SERVICE BULLETIN

NACELLE - POWERPLANT - FIRE PROTECTION - CORE ZONE FIRE DETECTOR - CLIPPING POINT - DELETION OF - CATEGORY 4. ACCOMPLISH AT THE FIRST VISIT OF THE NACELLE OR NACELLE COMPONENT TO A MAINTENANCE BASE CAPABLE OF COMPLIANCE WITH THE ACCOMPLISHMENT INSTRUCTIONS REGARDLESS OF THE PLANNED MAINTENANCE ACTION FOR THE NACELLE OR NACELLE COMPONENT. - MOD.NAC-26-0004

V2500-NAC-26-0004

Clipping Point 5723 After Alteration
Fig.6

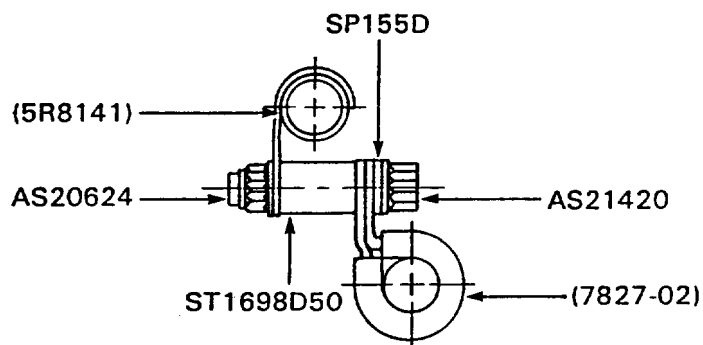
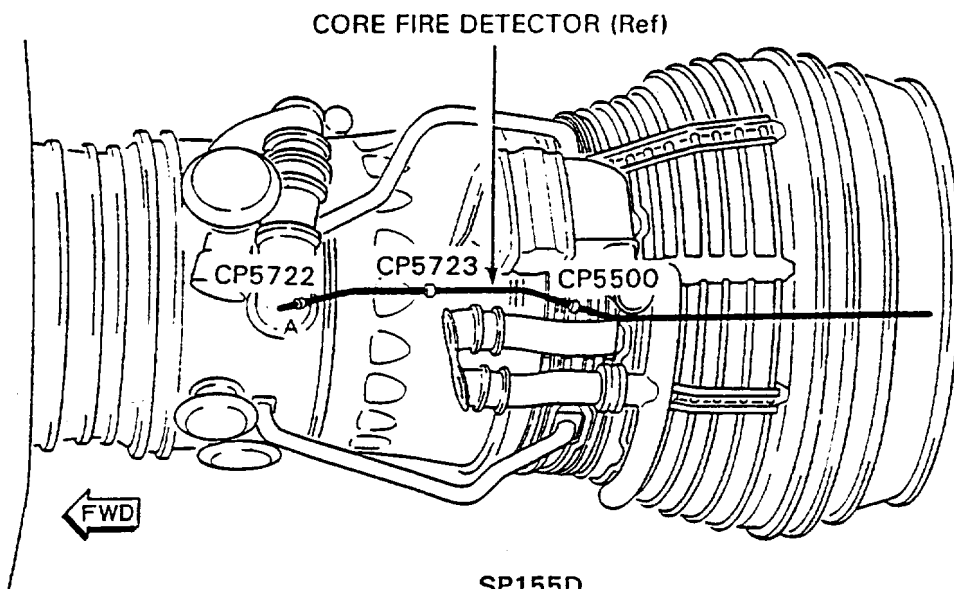
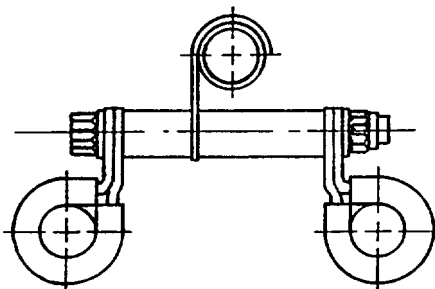
- (1) Remove an AS21420 bolt, SP155D washer, ST1698D50 spacer and an AS20624 nut from clipping point CP5723 (Refer to Figure 1.)

VIEW LOOKING REARWARD
CLIPPING POINT 5723 (EBU)
BEFORE ALTERATION

VIEW LOOKING REARWARD
AFTER ALTERATION
FOR REFERENCE ONLY

NOTE: For assembly instructions on the new configuration of clipping point CP5723, refer to Section 1.b.
